- 7. Questa Woods Estates No. 9; KPB File 2026-033
McLane Consulting Group / Branson, Elhard
Location: Bruno Road, Teakwood Lane & Southgate Court
Bear Creek Area**

**ITEM #7 - PRELIMINARY PLAT
QUESTA WOODS ESTATES PLAT #9**

STAFF REPORT

QUESTA WOODS ESTATES #9
REPLAT OF TRACT A1B QUESTA WOODS ESTATES #8 (HW2004-013) & TRACT B1 QUESTA WOODS ESTATES #6 (SW2003-014)

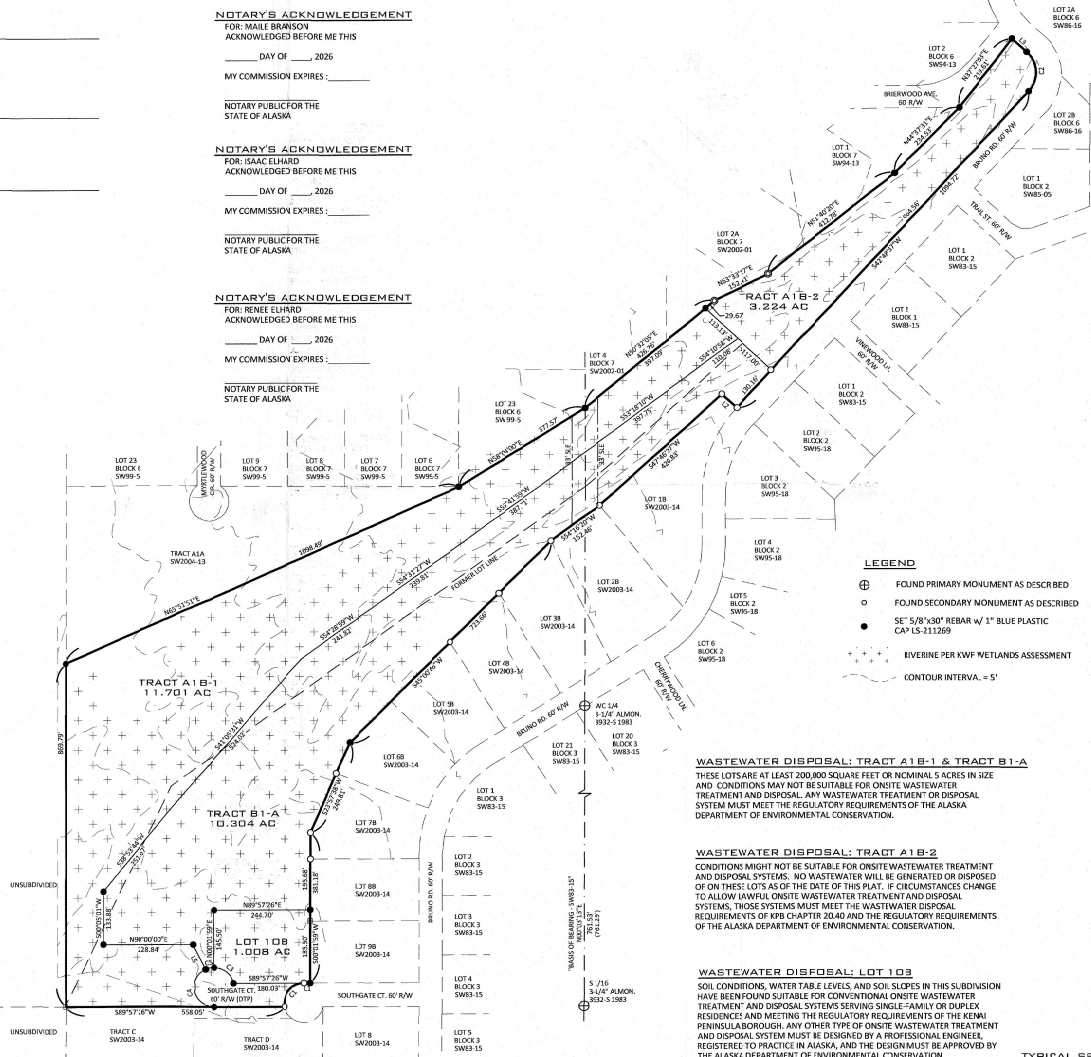
The plat is proposing to extend the existing cul-de-sac of Southgate Ct further into the subdivision to create access for three new parcels. **Staff recommends** the surveyor add dimensions to the cul-de-sac (overall curve) and south line of the plat.

A 66' Section Line Easement affects the plat as drawn on the plat. **Staff recommends** the surveyor identify the SLE on the drawing more prominent and tie to plat note 10.1.

The River Center review has identified the plat to be located in a FEMA designated flood hazard zone and floodway. The recommended flood hazard notice is included on the plat at note 7.1. Per the RC review, the note should include the FEMA FIRM Panel and zone and zones should be defined on the drawing. The floodway notice in KPB 20.30.280.E needs to be added to the plat notes and include the FEMA FIRM Panel and the floodway needs defined on the drawing also.

The Typical Setback Detail is overlapping onto the Plat Approval, please space apart
Correct Reene Elhard name in the Notary’s Acknowledgement.
Add measured data where needed.
Note basis of bearing.

- Staff recommendation:**
Modify the KPB File No to 2026-033
Add to the legal SW1/4 Section 13, as a small portion of Tract B1 is in the SW1/4 of Section 13

- C. The location, width, and name of existing or platted streets and public ways, railroad rights-of-way, and other important features such as section lines or political subdivisions or municipal corporation boundaries abutting the subdivision;
Staff recommendation:
Show Myrtlewood Cir and Oakwood St north of plat with ROW width

- D. A vicinity map, drawn to scale showing location of proposed subdivision, north arrow if different from plat orientation, township and range, section lines, roads, political boundaries, and prominent natural and manmade features, such as shorelines or streams;
Staff recommendation:
 Add Southgate Ct to the vicinity map.

- G. The status of adjacent lands within 100 feet of the proposed subdivision boundary or the land status across from any dedicated rights-of-way that adjoin the propose subdivision boundary, including names of subdivisions, lot lines, block numbers, lot numbers, rights-of-way; or an indication that the adjacent land is not subdivided;
Staff recommendation:
 Lot to north marked 23 needs corrected Lot 5A block 7 SW 2001-15
 Lot 4 Block 7, shape needs adjusted to show road in NW corner.

- N. Apparent encroachments, with a statement indicating how the encroachments will be resolved prior to final plat approval;
Staff recommendation:
 Looks to be some houses along the backside of Lots 4B & 1B may be encroaching with structures
